August 24, 2021

RE: Proposed 40B Development Located at 518 South Avenue
Preliminary Comments – Revised Groundwater Mounding Analysis

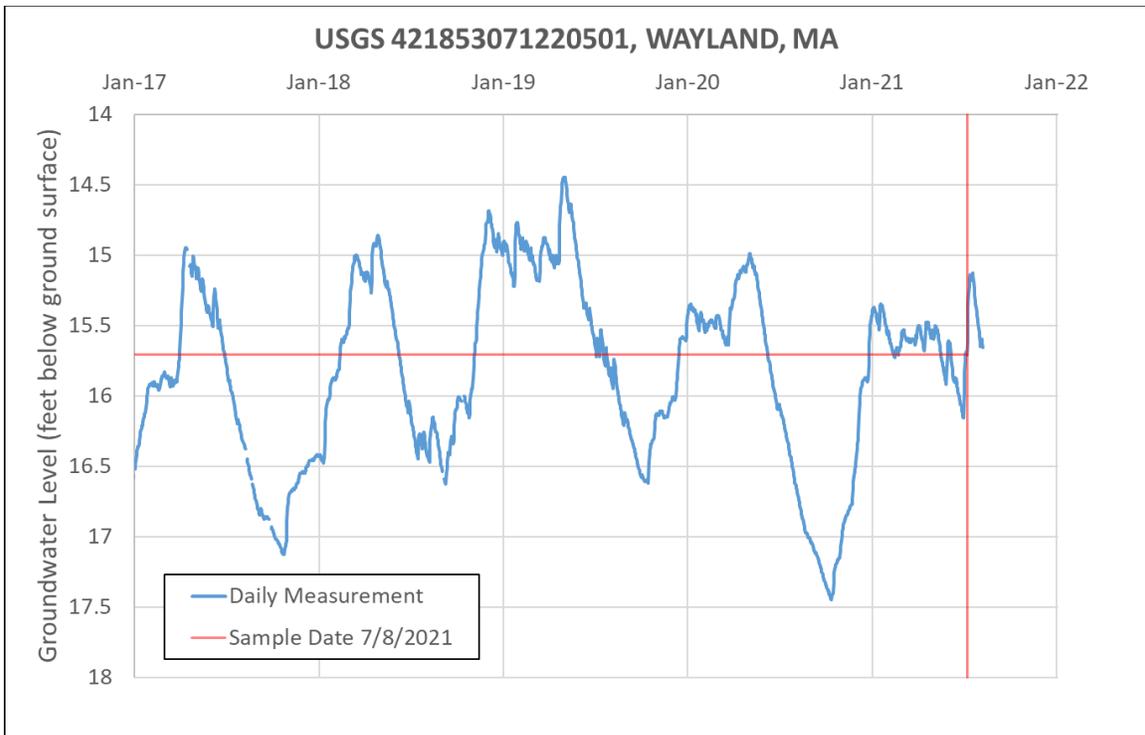
First, Appendix C of the Revised Modeling Report presents soil testing results generated by Metrowest Engineering, Inc. (Metrowest) that are inconsistent with the seasonal high groundwater elevations used in the Revised Modeling Report. According to Metrowest, Redoximorphic features (i.e., "mottling") were identified in discrete vertical intervals within seven of the nine test pits, including the two located in the

general vicinity of the proposed primary wastewater infiltration area. Metrowest reports the interpreted elevations at which these features occur as being representative of the “Design Water Table”, which is generally consistent with the methodology described by 310 CMR 15.103(3)(a). But near the proposed primary wastewater infiltration area where the Metrowest observations suggests high water table conditions reside around approximately 214 feet, NAVD88², comparable groundwater elevations reported by SHA for July 8, 2021 occur approximately two (2) feet lower (i.e., SH-208W measured at 211.93 feet, NAVD88 and SH-103 measured at 211.9 feet, NAVD88).
